RIVERWOOD SUBDIVISION,

PHASE ONE

APPLICATION NUMBER 26 DATE April 7, 2005
APPLICANT Riverwood Subdivision, Phase One
REQUEST Subdivision

DETAIL SITE PLAN

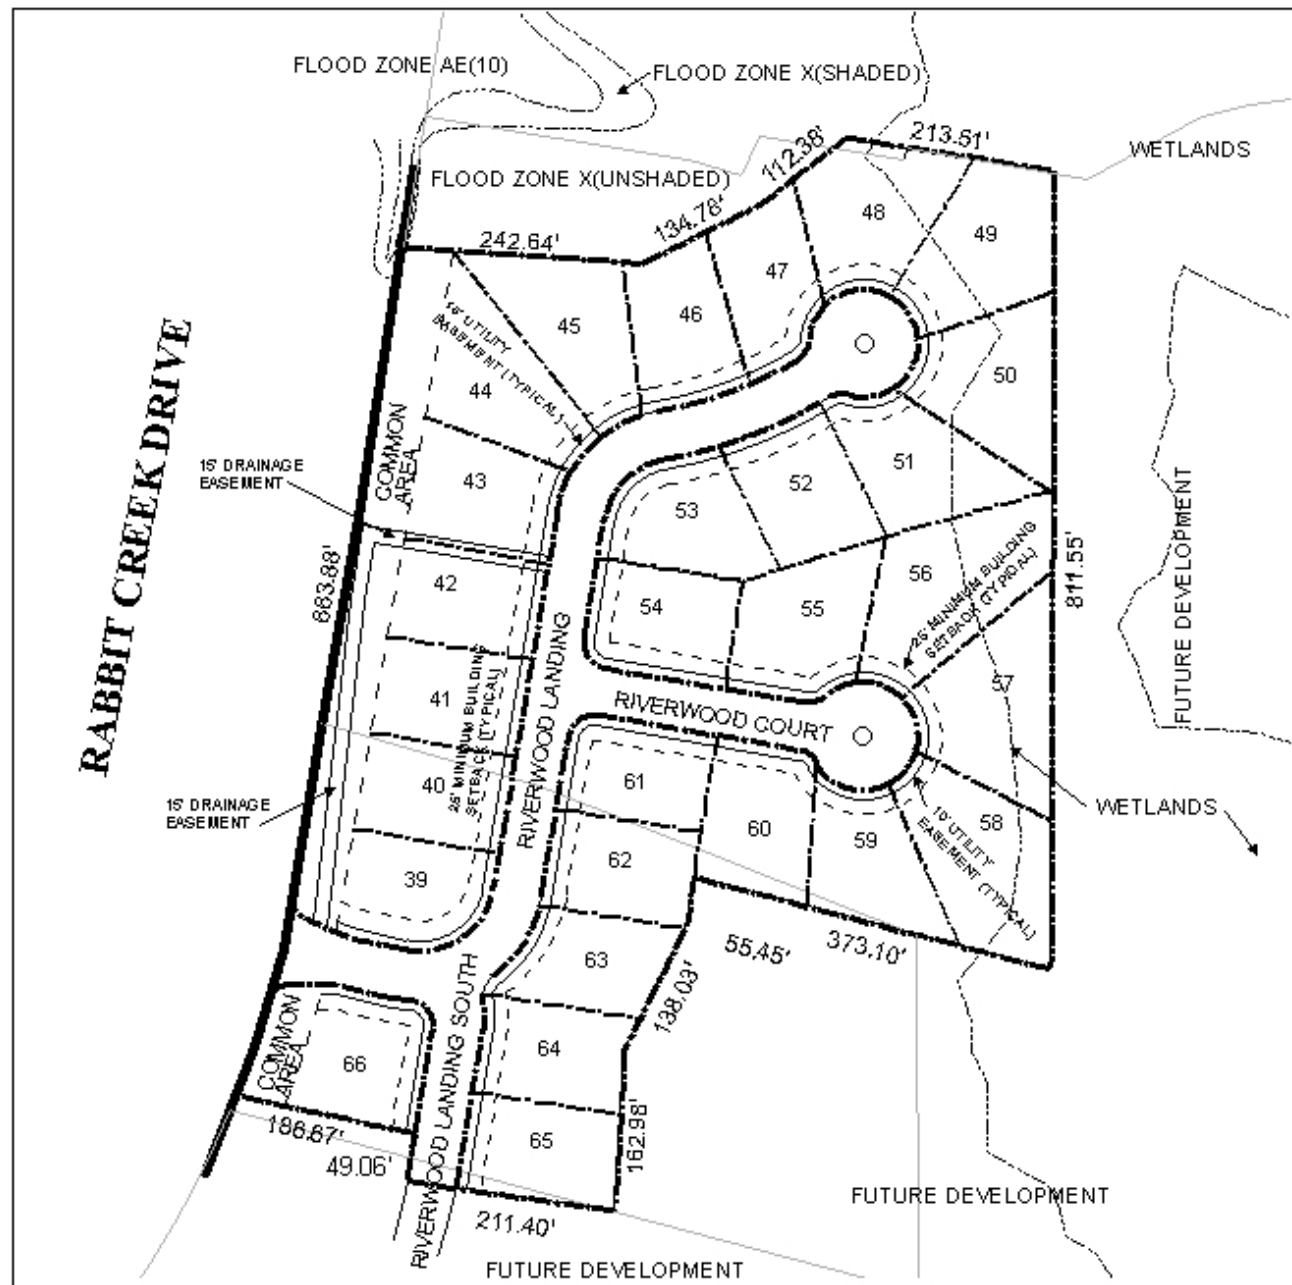
The site is part of a previously approved subdivision, and this phase is virtually identical to the plat for the previous approval. While the lot configuration is the same as the previous approval, there are concerns relating to wetlands that could impact the lot configuration at the ends of the cul de sacs. The wetlands were not depicted on the previous submissions; therefore, no conditions relating to wetlands were attached to the previous approvals.

The Commission has generally taken a conservative approach to development of properties containing wetlands, and frequently required that the minimum lot area (7,200 sq.ft.) be exclusive of wetlands. In this particular instance, at least two of the proposed lots would be significantly impacted (specifically lots 49 and 50 – at the end of Riverwood Landing), and do not appear to have adequate buildable area exclusive of the wetlands.

The plat reflects a large common area running adjacent to the Rabbit Creek Drive. The purpose of this common area is to provide a natural vegetative buffer and allow for a drainage easement. The plat also indicates planting areas located in the center of the cul de sacs. All such planting areas should be noted as common areas, and a note required on the final plat stating that maintenance of all common areas shall be the responsibility of the property owners. While neither the Planning Commission nor County Commission has authority over restrictive covenants, maintenance provisions should also be included in the restrictive covenants to notify purchasers of this responsibility.

Based on the preceding, it is recommended that this plat be granted Tentative Approval subject to the following conditions: 1) lots 48-58 be reconfigured to provide a minimum area of 7,200 sq.ft. exclusive of wetlands; 2) placement of a note on the final plat stating that maintenance of all common areas shall be the responsibility of the property owners; 3) placement of a note on the final plat stating that there shall be no curb cuts to Rabbit Creek Drive; 4) placement of a note on the final plat stating that buffers in compliance with Section V.A. 7 shall be provided ; and 5) developer to obtain approvals for all applicable federal, state and local agencies prior to the issuance of any permits
